PB# 91-06

EILEEN OSSMAN SD

OSSMANN, EILEEN SUBDIVISION (91-6) BEATTIE ROAD

PRELIMINARY PLAN FOR LANDS OF:
EILEEN C. OSSMANN
TOWN OF NEW WINDSOR,
ORANGE COUNTY, NEW YORK

DRIVEWAY PROFILE - LOT 2
SCALE = 1" = 5' VERT
1" = 50' HORIZ

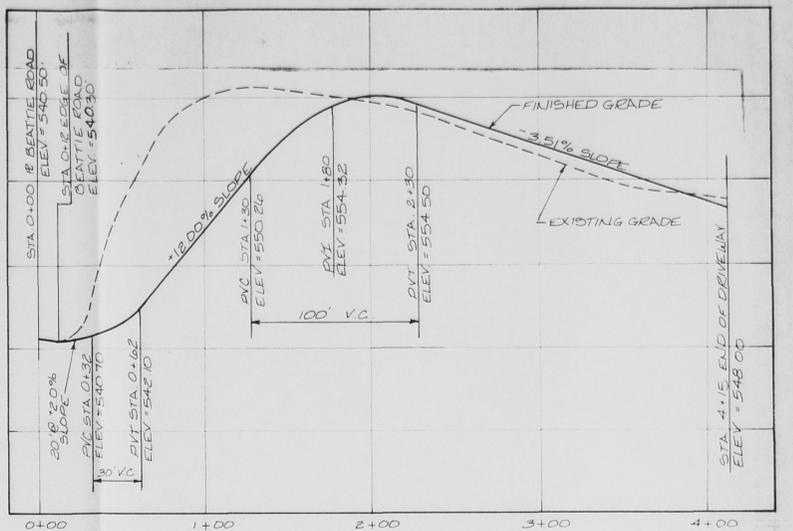
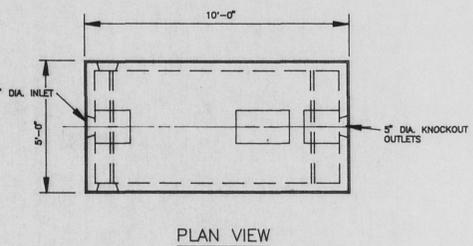
MR. SCHIEFER: Twelve (12) percent slope?

MR. SCHIEFER: And it's 3.5 where it comes out to the highway or am I misreading that?

MR. SCHIEFER: That's why I asked that question. It's just before the road that's a 12% slope right there coming out to the public highway.

MR. LANDER: You couldn't lessen that slope?

MR. SCHIEFER: I personally am not to happy with the slope of that driveway.

MR. SCHIEFER: But I see why there's nothing else you can do. He's already taken quite a cut but I still don't like it.

MR. NOSEK: This is the center line on Beattie Road. This would be the end of the driveway coming up to 12% and going back at a minus 3.15%, I believe that's what it is.

MR. NOSEK: No, the problem with lessening is that the cut becomes more substantial as you can see here. This is existing grade by coming in with the 12%, we're already up to probably 8 or 9 foot cut through there.
